IN THE UNITED STATES PATENT AND TRADEMARK OFFICE
BEFORE THE HONORABLE BOARD OF PATENT APPEALS AND
INTERFERENCES

Application No.: 10/500,713

For: METHOD FOR MANUFACTURING FILAMENTS FROM AN
OPTICALLY ANISOTROPIC SPINNING SOLUTION AND AIR GAP
SPINNING DEVICE

BRIEF ON APPEAL

Fig. 6

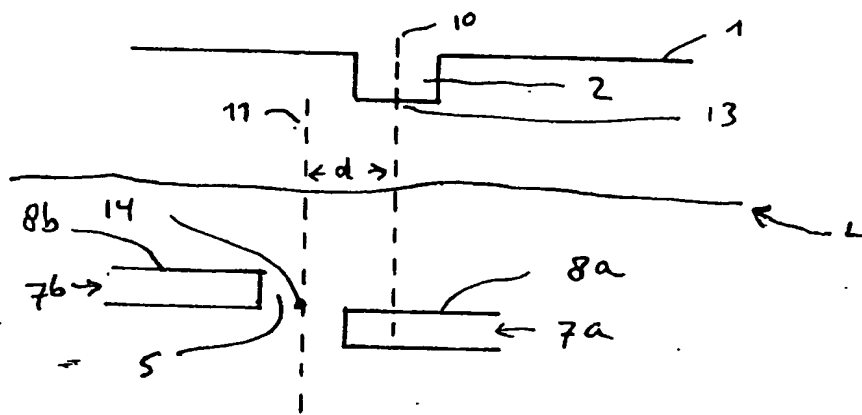
achieved by the embodiment described in paragraph [0043] and depicted in Figure 6. FACTS 36–44. Paragraphs [0010] and [0011] contrast the effects of coagulant streams flowing from adjacent discharge openings that are at the same level and of coagulant streams flowing from edges of adjacent discharge openings that are at different levels. FACTS 45–49, 7–12.

Moreover, as discussed above, paragraph [0009] teaches that paragraphs [0010] and [0011] explain why the configuration depicted in Figure 6 leads to no substantial coagulation bath motion. FACTS 36–44. Figure 6 depicts edges of the opening being at different levels. FACT 26. Paragraphs [0010] and [0011] explain that discharge openings with edges at different levels leads to a calm coagulation bath surface. FACTS 45–49, 7–12. Thus, paragraphs [0009] to [0011] teach that the slot/diaphragm configuration depicted in Figure 6 implicitly corresponds to the discharge opening with edges at different levels discussed in paragraphs [0010] and [0011]. Because the discharge opening is

Original Figure 2

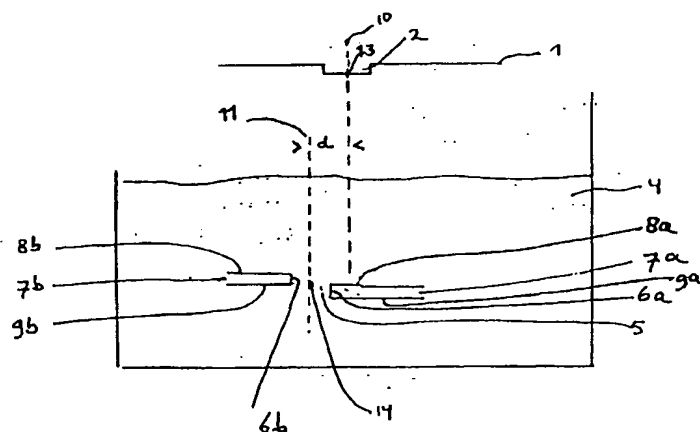
As has been repeatedly discussed, Applicants respectfully submit that the outermost line defining the boundary of the bottom of the bath in original Figure 2 was drawn in error, and this boundary should have been drawn as being contiguous with the bottoms of the slots 7a and 7b. This is the issue at dispute. However, regardless, Applicants note that original Figure 2 *also* did not show the "discharge opening" in the bottom of the bath. Paragraph [0003] of the specification as originally filed clearly discussed the "discharge opening[]" in the bottom of the coagulation bath." The Office Action mailed February 4, 2008, agrees that "there must be an opening in the bottom of the coagulation bath shown in the original Figure 2." Office Action mailed February 4, 2008, page 6.

Therefore, regardless of whether *the slot or diaphragm* is located at the bottom of the bath, a *discharge opening* is clearly located at the bottom of the bath. A hypothetical Figure 2, showing the slot or diaphragm as was shown in original Figure 2, but also including a discharge opening at the bottom of the bath, is shown below.

Hypothetical Figure 2

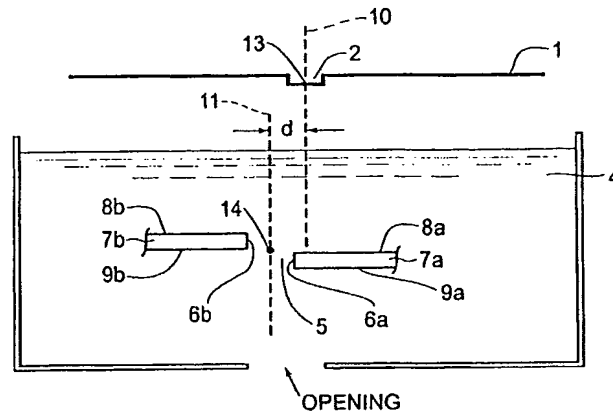
Applicants strongly stress that this Figure is hypothetical, and is presented only for the purposes of argument herein.

As an initial matter, applicant argues on pages 2-4 that either hypothetical Figure 2 or amended figure 2 must be correct. The examiner submits that there is no disagreement with the fact that the original specification provides support for an opening at the bottom of the coagulation bath. The issue at dispute is whether the original disclosure expressly, implicitly or inherently discloses that the slot or diaphragm is the same as the discharge opening. In this regard, the examiner maintains the objection to amended Figure 2 and the 35 USC 112 first paragraph rejection of the claims.

In arguments one and three, applicant argues that the geometry of the slot is clearly the geometry of the coagulation bath's bottom. This argument is not persuasive. The examiner notes, for example, that hypothetical Figure 2 also reasonably is understood to provide the required geometry. Further, the examiner submits that the linkage of the word "geometry" does not expressly, implicitly, or inherently, link the location of the slot or diaphragm and the discharge opening itself. Further still, the examiner points again to paragraphs [0018] and [0029] as set forth above, which demonstrates that the bottom of the coagulation bath and the slot or diaphragm do not "necessarily" correspond to each other as set forth in the arguments.

Amended Figure 2

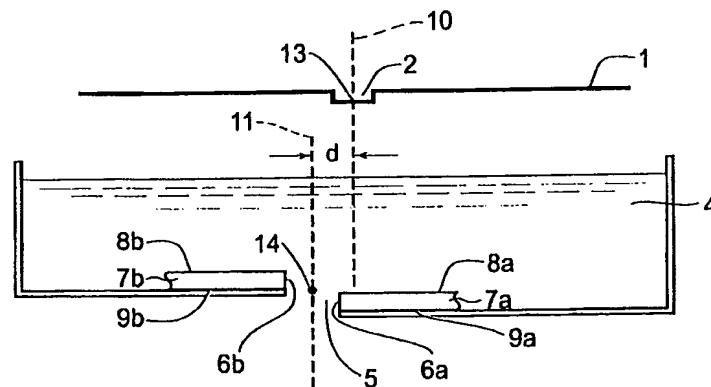
The amendment to the drawings filed April 30, 2007 is objected to under 35 U.S.C. 132(a) because it introduces new matter into the disclosure. 35 U.S.C. 132(a) states that no amendment shall introduce new matter into the disclosure of the invention. The added material which is not supported by the original disclosure is as follows: Figure 2 has been modified to show the plates and the slot or diaphragm at the bottom of the coagulation bath. This objection may be overcome by pointing to the location in the original disclosure where support for this amendment may be found. Otherwise, applicant is required to cancel the new matter in the reply to this Office Action.

examiner submits that such an argued connection between the slot or diaphragm and the discharge opening only appears feasible after viewing revised Figure 2 (which the examiner maintains also contains new matter) and that such a connection is not expressed, implied or inherent in the original disclosure.

The amendment to the drawings filed April 30, 2007 is objected to under 35 U.S.C. 132(a) because it introduces new matter into the disclosure. 35 U.S.C. 132(a) states that no amendment shall introduce new matter into the disclosure of the invention. The added material which is not supported by the original disclosure is as follows: Figure 2 has been modified to show the plates and the slot or diaphragm at the bottom of the coagulation bath. This objection may be overcome by pointing to the location in the original disclosure where support for this amendment may be found. Otherwise, applicant is required to cancel the new matter in the reply to this Office Action.

positioned at the bottom of the coagulation bath", as shown in replacement Figure 2 filed April 30, 2007, does not appear to be supported by the original disclosure. Claims 3-7 are rejected as dependent claims. This rejection may be overcome by pointing to the location in the original disclosure where support for this limitation may be found.

With the above two Figures in mind, Applicants respectfully submit that the issue of whether the slot or diaphragm is located at the bottom of the coagulation bath can be restated as *whether the slot or diaphragm corresponds to (i.e. is the same as) the discharge opening*. As has been previously discussed throughout prosecution, Applicants submit that the discharge opening corresponds to the slot or diaphragm (see Declaration filed April 28, 2008, page 4) such that only one actual opening is present in the bottom of the bath. This is the configuration as shown in amended Figure 2. Amended Figure 2 is shown below.

Applicants note that either "Hypothetical Figure 2" or "Amended Figure 2" *must* be correct, in that the only possible options are that either (1) the slot or diaphragm is located *on* the

discharge opening as in Amended Figure 2, or (2) the slot or diaphragm is located some distance above the discharge opening as in Hypothetical Figure 2.

(1) Paragraph [0003] of the present specification as originally filed states that "the extent to which the coagulation bath surface is in motion is highly dependent on the geometry of the coagulation bath's *bottom*" (emphasis added). Therefore "the extent to which there is motion at the coagulant surface can be reduced substantially by introducing *the geometry of the present invention*" (emphasis added). Applicants respectfully submit that the description of the "slot or diaphragm" throughout the present specification is clearly the "present invention" referenced in paragraph [0003]. See, for example, paragraphs [0004] and [0005] describing the geometry of the slot or diaphragm under "Summary of the Invention." Therefore, the geometry of the "slot or diaphragm" is clearly the "geometry of the coagulation bath's *bottom*" as described in paragraph [0003]. Thus, the slot or diaphragm is located at the bottom of the bath, in accordance with Amended Figure 2.

(2) Paragraph [0007] describes how "at the edges of the *discharge openings*, the liquid, which is entrained by the outgoing filament bundle is stopped or scraped off" (emphasis added) resulting in "streams flowing in opposite directions." Paragraph [0008] describes how "when the aforementioned streams come together at *different levels*... the liquid surface remains calm," (emphasis added) and therefore advantageous effects are achieved. Applicants respectfully submit that the "different levels" discussed in paragraph [0008] clearly arise from the geometry of the plates making up the slot or diaphragm, wherein

Accordingly, for these four reasons, as well as all of the reasons discussed previously throughout prosecution, a person having ordinary skill in the art would have understood that Amended Figure 2 is necessarily implicitly disclosed by the specification as originally filed. Thus, Amended Figure 2 does not constitute new matter.
